R.E. Ginna Nuclear Power Plant

**SUBJECT:** R.E. Ginna Nuclear Power Plant  
Docket No. 50-244

**Supplemental Information Related to Small Break (SB) Loss of Coolant  
Accident (LOCA) Analysis and Post-LOCA Boric Acid Precipitation  
Analysis**

Figure 8: Broken Loop and Intact Loop Pumped SI Flow Rate 3-Inch Break

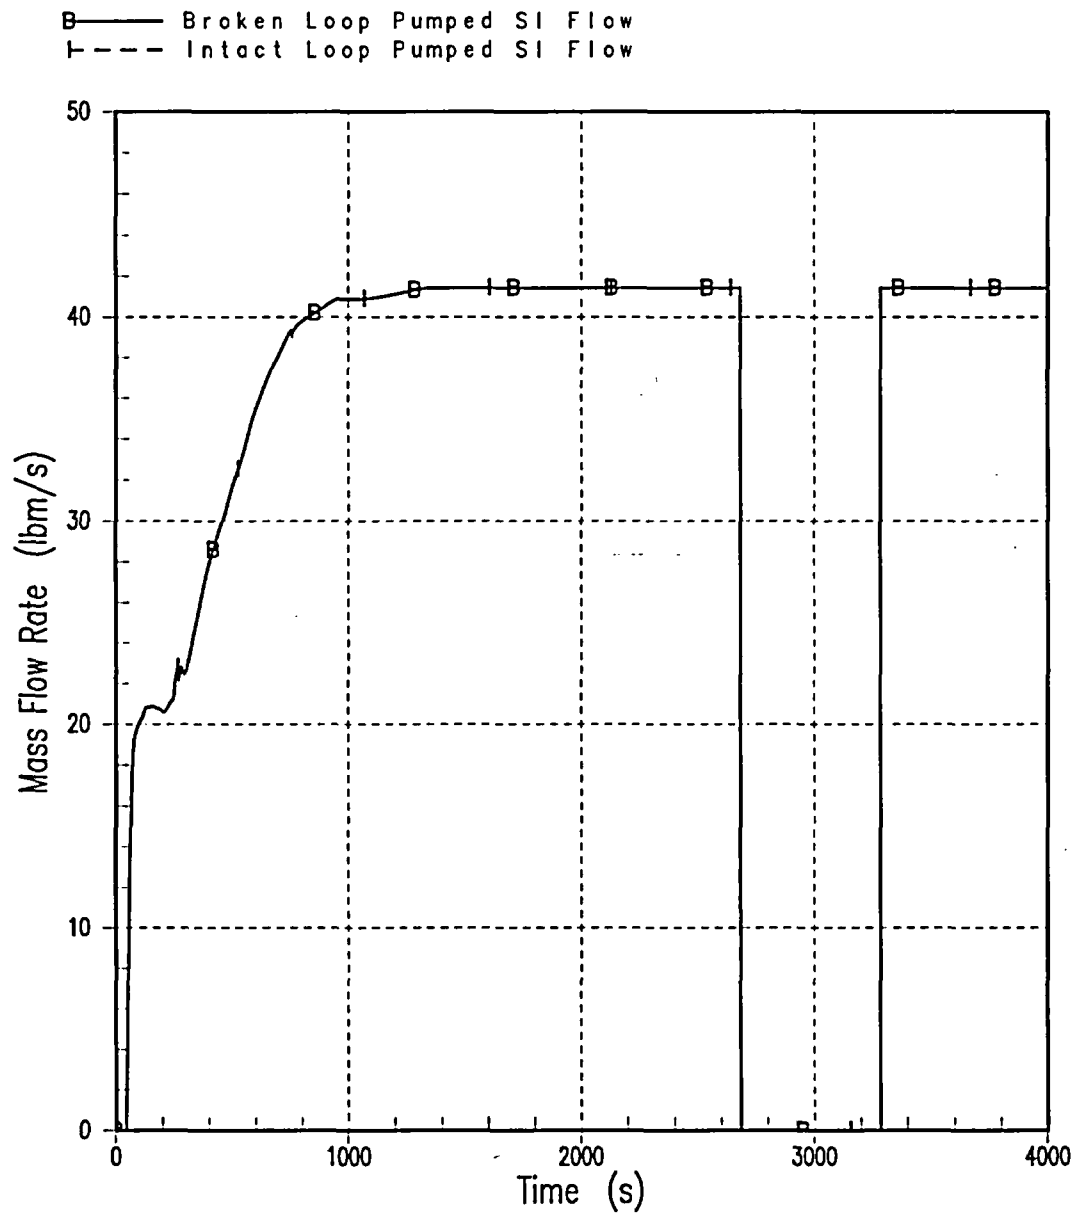
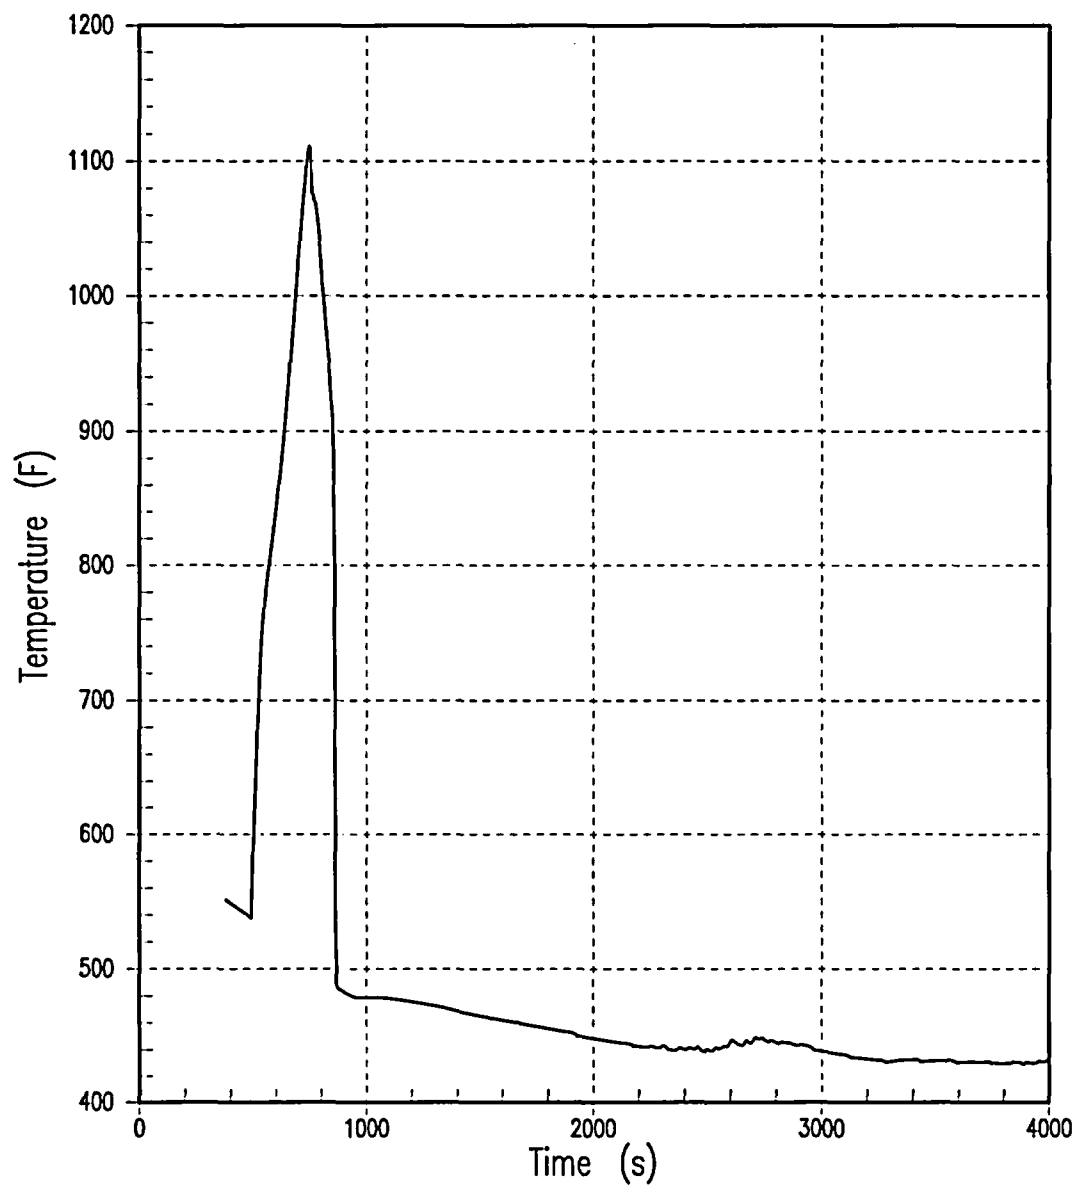
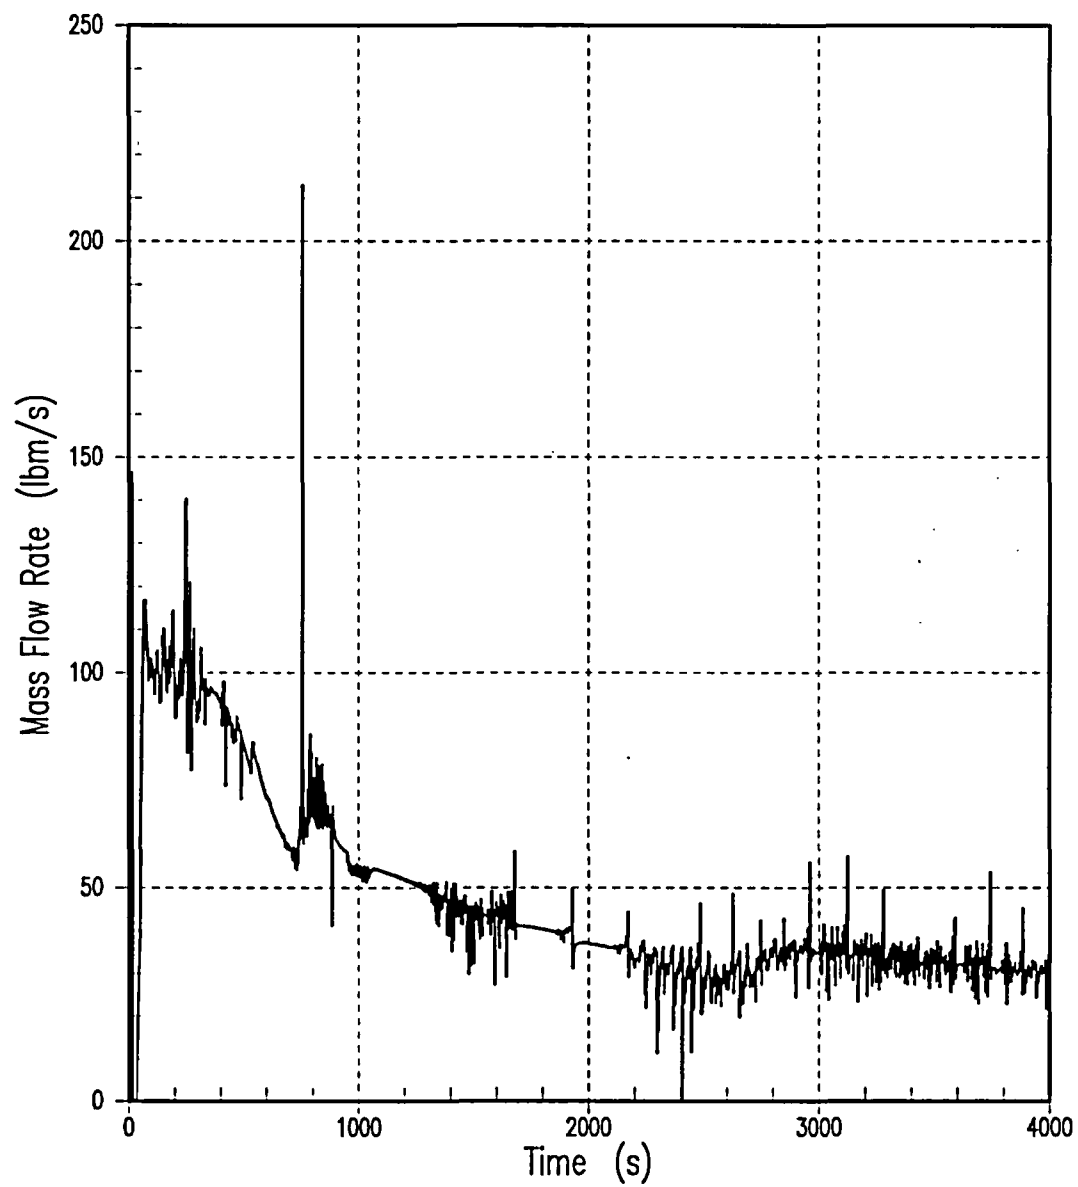
This letter responds to verbal requests for information received during a phone call with the NRC staff on August 11, 2005 related to the R.E. Ginna Nuclear Power Plant (Ginna) Extended Power Uprate (EPU). The requested information relates to the Small Break (SB) Loss of Coolant Accident (LOCA) analysis and the post-LOCA boric acid precipitation analysis. This additional information should clarify the evaluation methods used for the Ginna EPU in these areas to allow the NRC staff to proceed with its detailed technical review of the EPU.

The SBLOCA and post-LOCA boric acid precipitation analyses for the Ginna EPU were provided to NRC in Reference 1 [Pre-submittal to NRC dated 4/29/05]. Tables 4 and 5 of Enclosure 6 to Reference 1 provide a listing of SBLOCA transient and rod heat up results, respectively, for the 1.5", 2" and 3" breaks analyzed. SBLOCA transient parameter plots were only provided for the limiting 2" break in Reference 1. Enclosure 1 to this letter provides similar parameter plots for the 1.5" and 3" breaks analyzed and documented for the Ginna EPU. In addition, although not documented in the analysis, 4" and 6" break size transient calculations for the Ginna EPU were performed to demonstrate that no core uncover occurred for these breaks, thereby confirming that the range of breaks analyzed contained the limiting break. Additional SBLOCA transient behavior can be found in NRC-approved topical report, Reference 2 [WCAP-10054-P-A, Addendum 2, Revision 1].

**Supplemental Information on the Potential for Boric Acid Precipitation**

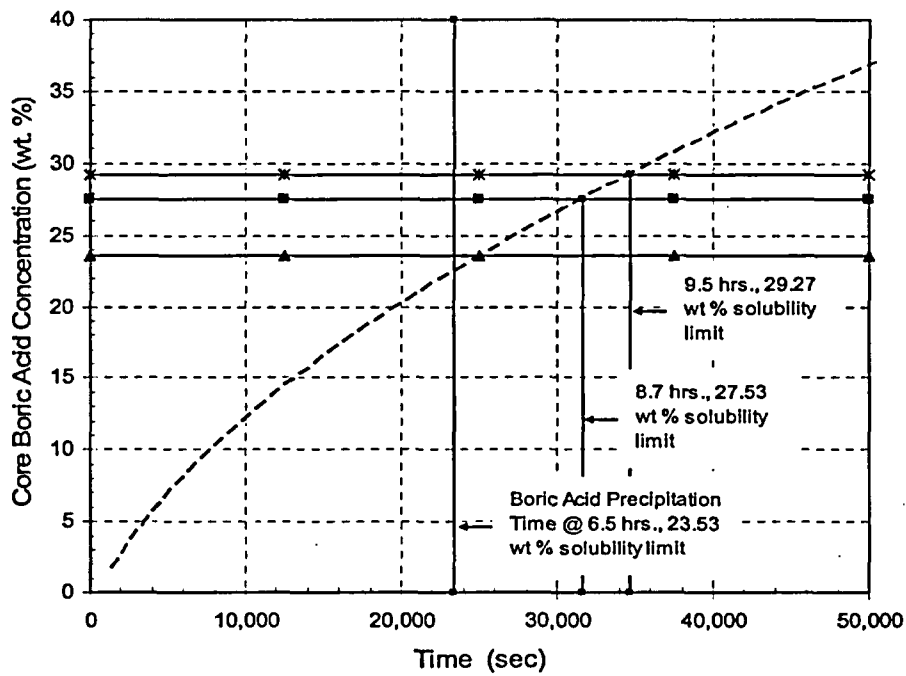
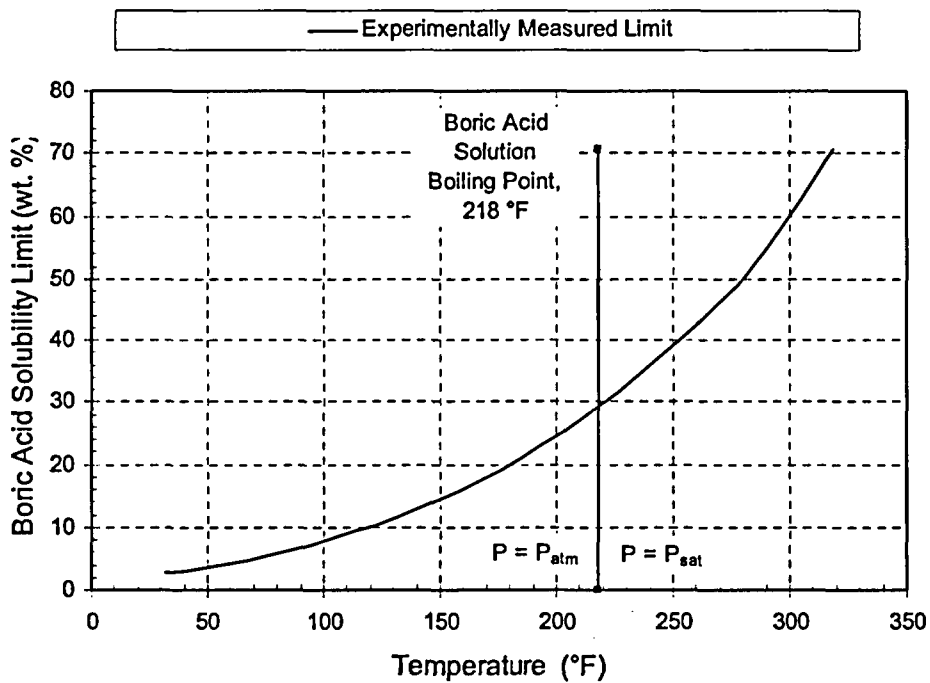
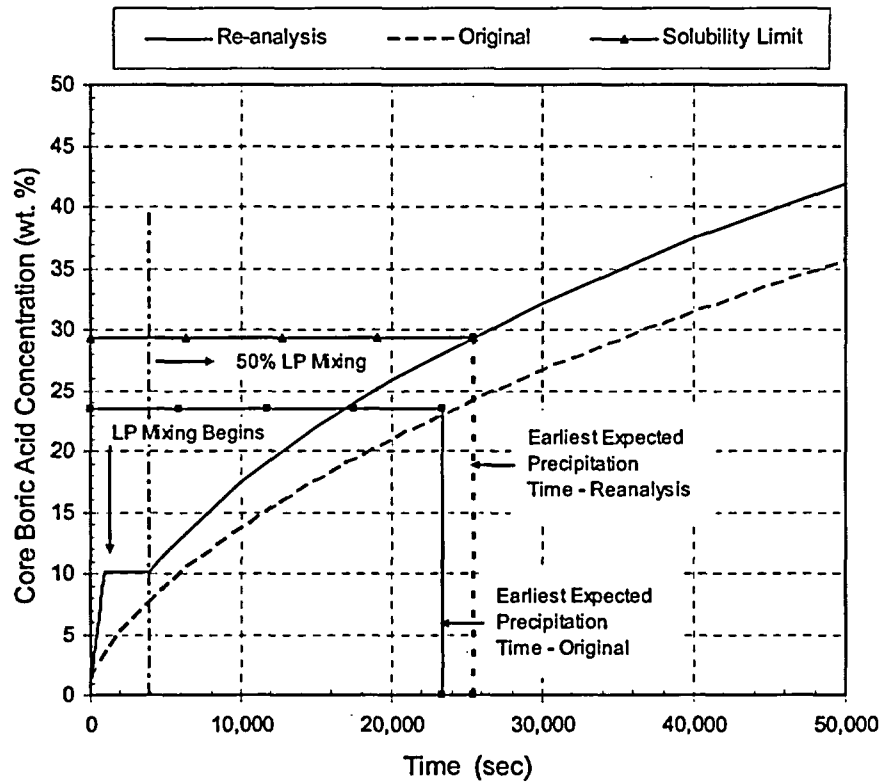
A recent NRC letter to Westinghouse (Reference 1) suspended the approval of a post-LOCA long-term cooling topical report applicable to CE plant designs citing issues related to the potential for boric acid precipitation. While the subject topical report and methodology are not directly applicable to Ginna, issues raised in the NRC letter have prompted the following clarifications and additional information regarding the Ginna boric acid precipitation analysis.

Reference 1 raises a number of issues related to the methodology used to establish the maximum length of time before UPI initiation after which boric acid precipitation might occur. The most significant issues are the decay heat assumption and the consideration of core and upper plenum voiding as it affects the analysis for determining liquid mixing volume. The Ginna calculations used a best estimate decay heat assumption and neglected voiding as did the calculations for the as-submitted Beaver Valley Units 1 and 2 EPU LAR. Recent boric acid re-analysis cases performed in response to RAIs for Beaver Valley Units 1 and 2 EPU LAR (Reference 4) show that best estimate decay heat assumption and neglected voiding are offset by partial credit for mixing in the lower plenum and by taking full credit for the experimentally determined boric acid solubility limit at the atmospheric boiling temperature of a water/boric acid solution (Figure 2). Figure 3 shows the original and re-analyzed boric acid concentration transient for the Beaver Valley Unit 1 EPU. It is expected that revised calculations for Ginna would show the same result.

Since Ginna is an upper plenum injection (UPI) design with low head safety injection directly to the upper plenum, conventional 3-loop and 4-loop hot leg recirculation switchover or simultaneous recirculation switchover post-LOCA actions do not apply. Simultaneous hot (UPI) and cold side (SI) injection will occur automatically when RCS pressure decreases below the low head RHR injection pressure (140 psia). Boric acid precipitation calculations are performed only to establish the maximum length of time before UPI initiation after which boric acid precipitation might occur. After UPI and after the start of sump recirculation, the cold leg SI is normally terminated. The calculated time also is conservatively used to establish the time after which cold leg SI injection should be reestablished, once it is terminated. This time will be specified in the Emergency Operating Procedures. Details on specific ECCS design and the anticipated operator actions are given in Enclosure 7 of the Ginna Tech Spec LAR (Reference 2). The calculated core region boric acid concentration as a function of time for a large break LOCA for the Ginna EPU is given in Figure 1. This analysis was performed consistent with, or conservative with respect to, Reference 3, which has been the NRC accepted method for Westinghouse design plants and the method that supports the current Ginna design basis analysis. The Reference 3 methodology treats small breaks as non-limiting because of the benefits of lower core voiding, greater SI subcooling, and the higher boric acid solubility limit for SBLOCA RCS pressures.
